RESPONSE TO SCCPP COMMENTS LETTER

HAMPSTEAD ROAD COMMERCIAL - STAGE 1 [19_066] – DA2020/0310

FIGURE 2: INCREASED WIDTH OF CROSS SITE LINK 2 – NOW COURTYARD/FORECOURT 2 TO ALLOW FOR MORE USES AT THE INTERIM TERMINATION OF THE LINK.

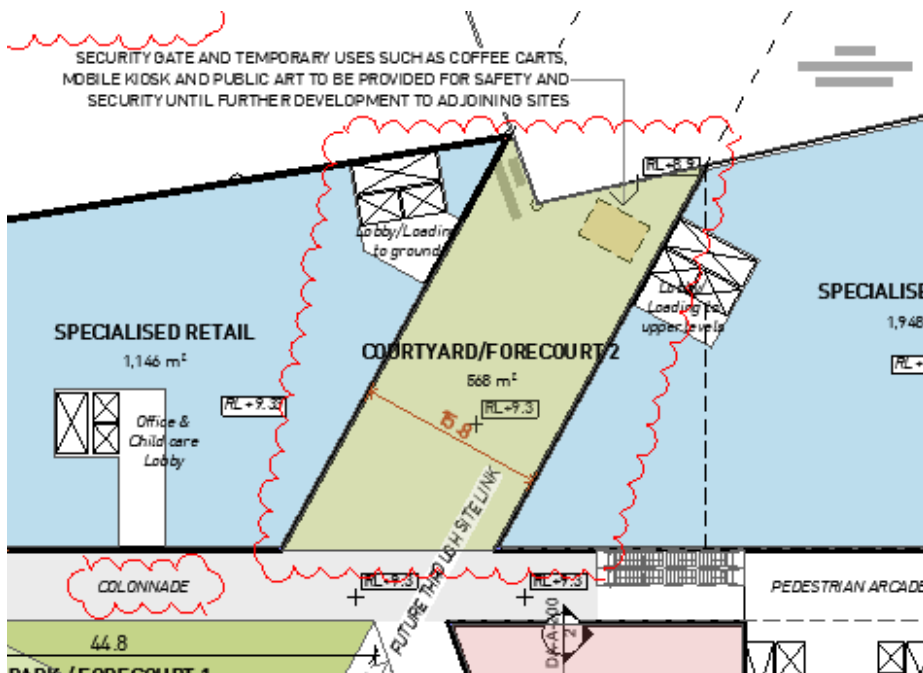
The northern cross site link follows the line of canal and former creek line. When the adjacent site is developed this will provide a connection to Parramatta Road. Public art has been proposed as part of the landscape strategy to increase awareness of the place, and the role of the waterway in the Duck River catchment.

We have amended plans to increase the width of this link to almost 16m to strengthen the connection and activate the building facades. This will improve its usability in the event its extension does not eventuate and will act as part of the entrance to the commercial buildings. It also creates a secondary space for passive recreation which contrasts and compliments the more active central park.
